# Service Alert

<b>Subject:</b>  FORWARD SENSING CAMERA (FSC) DYNAMIC AIMING NOT COMPLETED AND/OR DTC B14F0:76 STORED	<b>Service Alert No.:</b> SA-046/20
	<b>Last Issued:</b> 04/14/2020

This service alert supersedes the previously issued service alert listed below. The changes are noted in Red text.

2019 - 2020 MAZDA3  
2020 CX-30

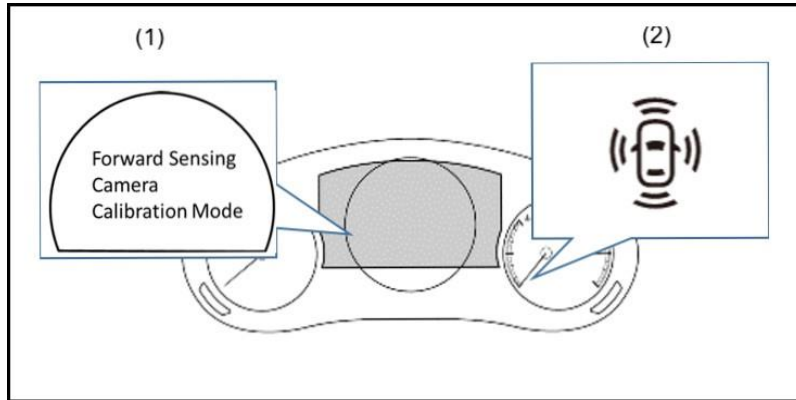
FSC dynamic aiming is completed if the following conditions are met:

1. "Forward Sensing Camera Calibration Mode" message (1) on instrument cluster MID disappears.
2. The i-ACTIVSENSE warning light (2) turns off.
3. Steps 1 and 2 are completed within 20 minutes from start of aiming.

- FSC dynamic aiming mode is finished after 20 minutes due to time limit, regardless of aiming completion.
- If FSC dynamic aiming cannot complete, perform stationary aiming (static aiming).
- **If FSC aiming is unsuccessful and DTCs B14F0:04 and/or B14F0:76 are stored, perform BCM configuration and then redo FSC aiming.**

- Perform the dynamic aiming with the sensor cover installed after a windshield replacement in order to reduce noise interruption.
- DO NOT turn the engine off while the dynamic aiming mode is activated or it may result in DTC B14F0:76 (VCM stored). If DTC B14F0:76 is stored, disconnect the negative battery terminal or related fuse and connect it again after 10 seconds. **If the DTC B14F0:76 cannot be cleared by disconnecting the negative battery terminal, FSC replacement is required.**
